SERVICE BULLETIN

APPLICABILITY: 2015-2017MY Legacy

NUMBER: 12-226-17

SUBJECT: Fuel Door Sticking Closed in Cold Weather

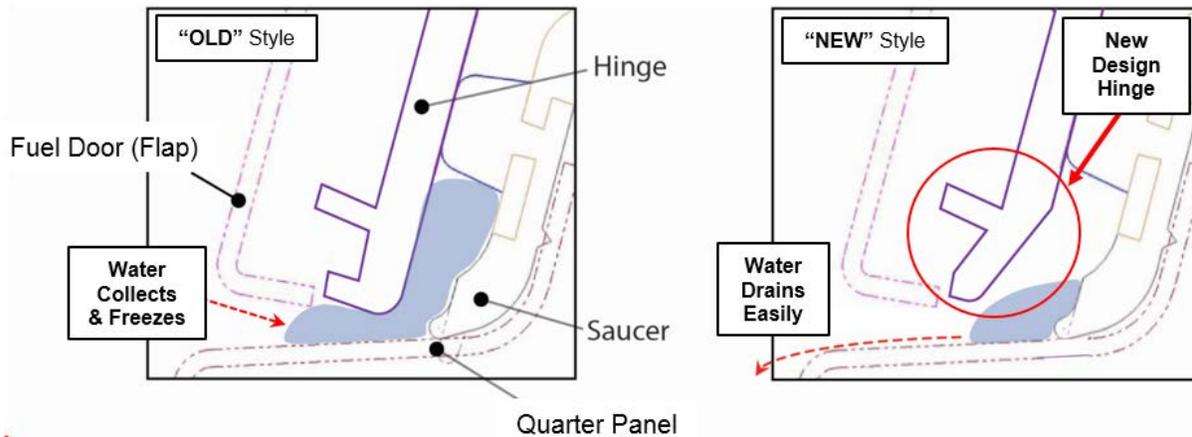
The part number for the new “SAUCER COMPLETE SDN” is: **51478AL01D**. The illustrations below provide a comparison between the “NEW” and “OLD” -style parts. The change involves a change made to the base of the hinge portion to improve drainage and prevent water accumulation. In sub-freezing temperatures, ice can form causing the fuel door to not open properly.
